after consideration of your feedback the following changes have been made:-

STUDIO STEAD		74 Marlborough Rd Washington Tyne & Wear NE37 3BT		Job		
RIBA		ARB		Catwick Farm		
Royal Institute of British Architects		ARB Registered Architect		Sneatonthorpe Whitby YO22 5JF		
Drawing		Proposed plans		Status		
				PLANNING		
Job No.	Dwg no.	Scale	Sheet Size	Date	Drawn	Revision
109	03	1:100	A3	May 2020	SS	A March 2021, amendments following NYMNP comments

CATWICK FARM

Proposed Roof plan
Scale 1:100

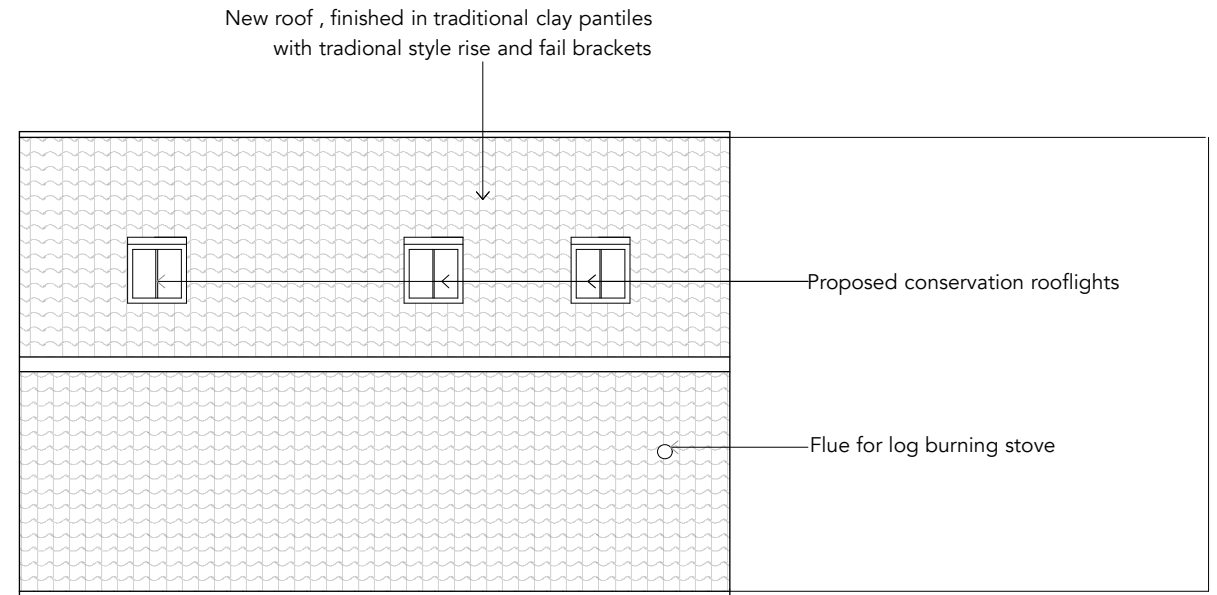
- New opening to lounge removed
- Rooflight sizes reduced.
- Rooflight design changed to conservation grade.

The previous roof lights were a 780 x 1400mm in size, they are now 780 x 1180mm conservation style. It would be very disappointing to remove any of the roof lights from a sustainable design point of view. The use of natural light and natural ventilation in the Ensuite is important and reduces energy consumption. The same goes for the rooflight above the living room which is providing high level southern light into this room. Yes there is a glazed door on the south side but the barn is overshadowed for large parts of the day, particularly in winter, by the main house.
